# HISTORIC LANDMARK COMMISSION

**RONALD McDonald HOUSE**  
**PLNHLC2011-00503**  
**901 East South Temple**  
**June 6, 2013**

The Ronald McDonald House, represented by CRSA Architects, is requesting that the Historic Landmark Commission review and approve an exterior finish material called Dryvit TerraNeo which is designed to simulate a rock finish on portions of the now under construction Ronald McDonald House (the design of the new building was approved by the Historic Landmark Commission on February 2, 2012).

Re: Staff Approval of Exterior Finish Systems required by HLC Approval  
Ronald McDonald House, Phase I  
BLD2012-04963

**East Elevation**

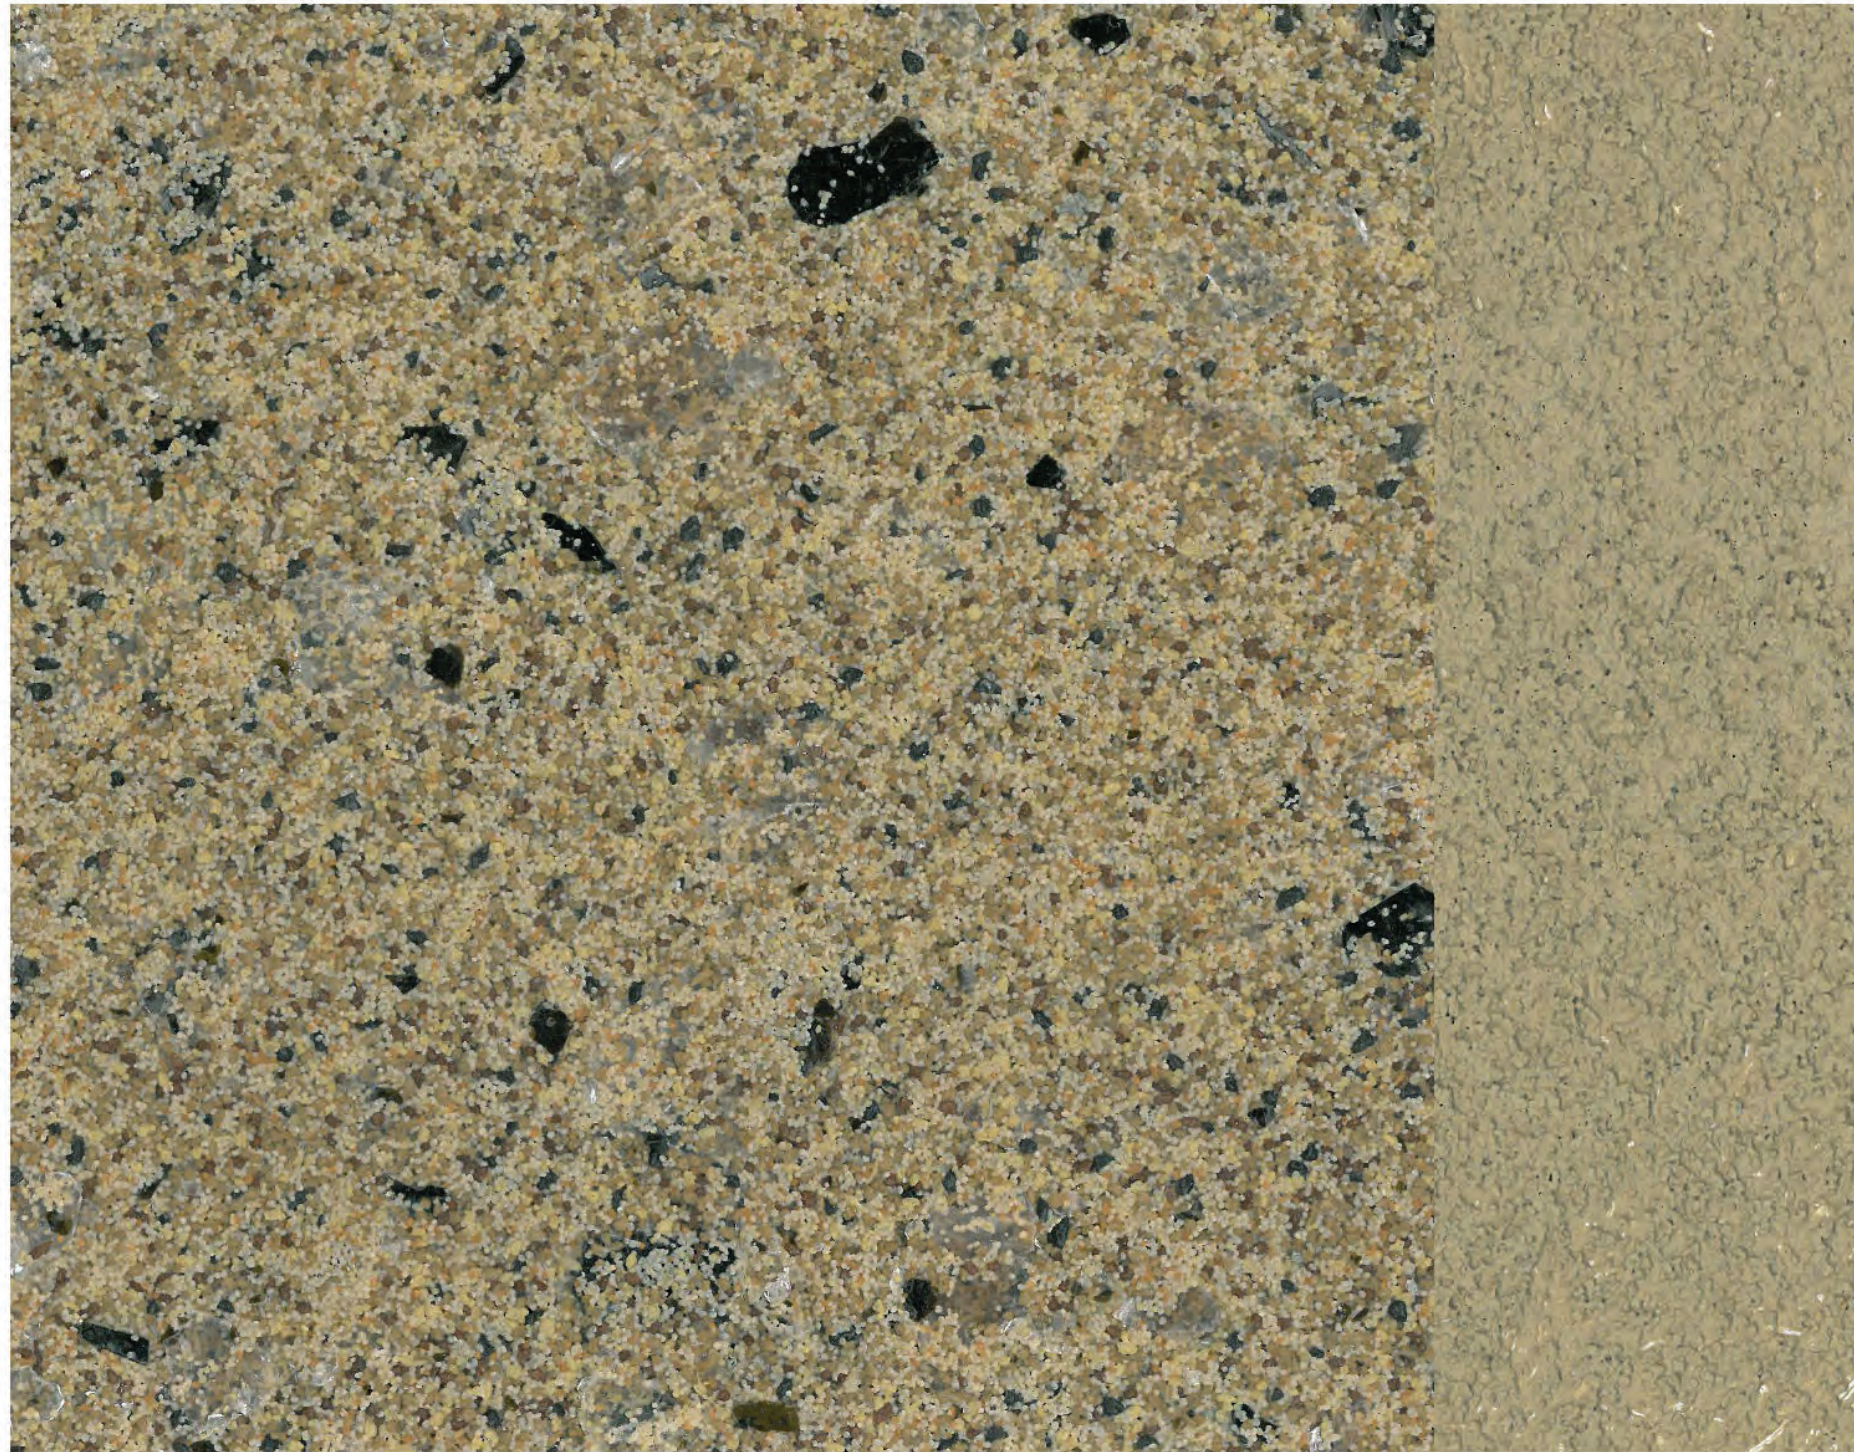
The attached, highlighted elevation diagrams show where brick and faux stone products will be installed on the subject project. Also attached are photographs of this product installed around the Salt Lake and Utah valleys which we observed to appear as faux stone. Observations of this or similar products on buildings constructed more than 15 years ago were noted as appearing to be the same quality as new installations, noting no visible degradation. This shows the product to be successful, long-lasting, and attractive after many years.

The TerraNeo installations we observed as most successfully representing stone were installed adjacent to another real material, i.e., real brick masonry or stone masonry. We believe this juxtaposition, along with care in detailing, will further enrich the visual attractiveness of the product. The RMH building will have installations of the TerraNeo product adjacent to brick at the vast majority of the transitions.

1. The material shall be applied only to those areas indicated on the plans attached to this staff report.

EXTERIOR MATERIALS  
Ronald McDonald House - Phase 1  
CRSA, 2013-April-03

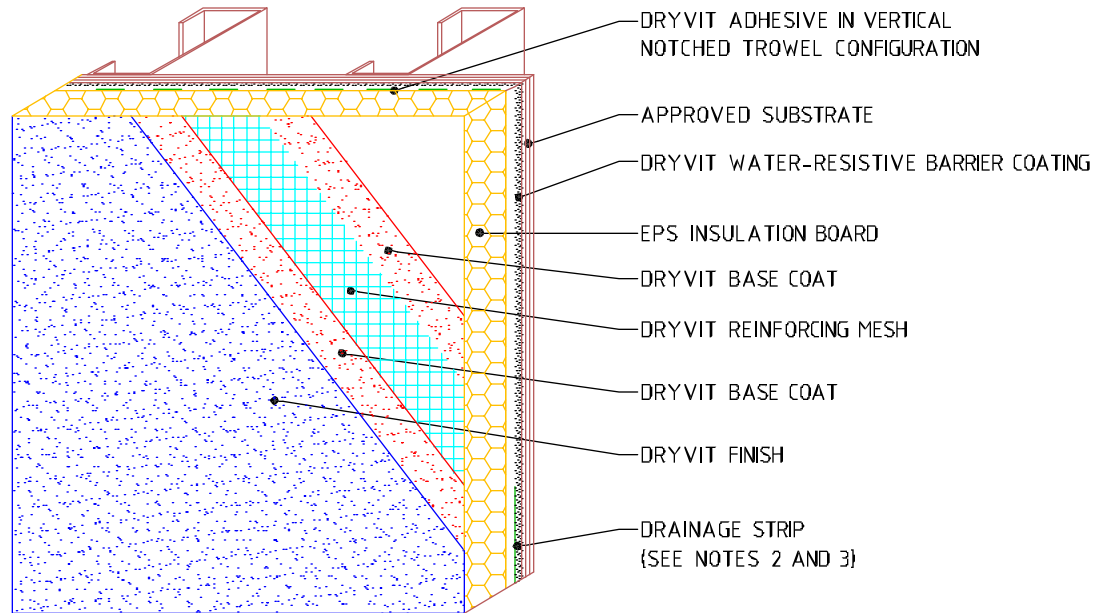
**TerraNeo faux stone**  
(Orange)

**Accent**  
(Pink)

EXTERIOR MATERIALS

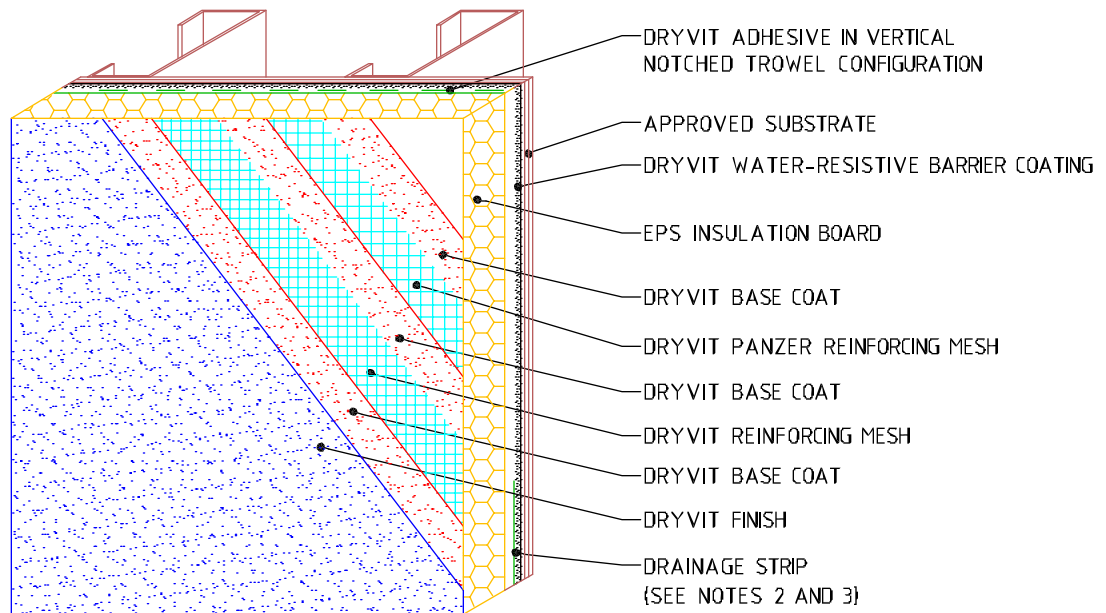
- Material – The faux stone system submitted for this application is Dryvit TerraNeo.
- Durability – Dryvit's standard reinforcing mesh will be used where this material is applied above the ground. Next to walking areas, upgraded reinforcing mesh gives this product added durability. Its' initial tinted scratch coat is almost 1/8" thick with a finish top coat also almost 1/8" thick, and high-traffic areas receive a third coat. With over ¼" thick coat on mesh, this product is durable and, better, it is repairable where the repair of actual stone would be formidable. Additionally, the system has insulative value. On vertical surfaces the topcoat is as durable and protective as a stucco product. Where it is installed on small sloped, horizontal surfaces, the product is sealed for added protection from water infiltration. The product has a 10-year warranty.
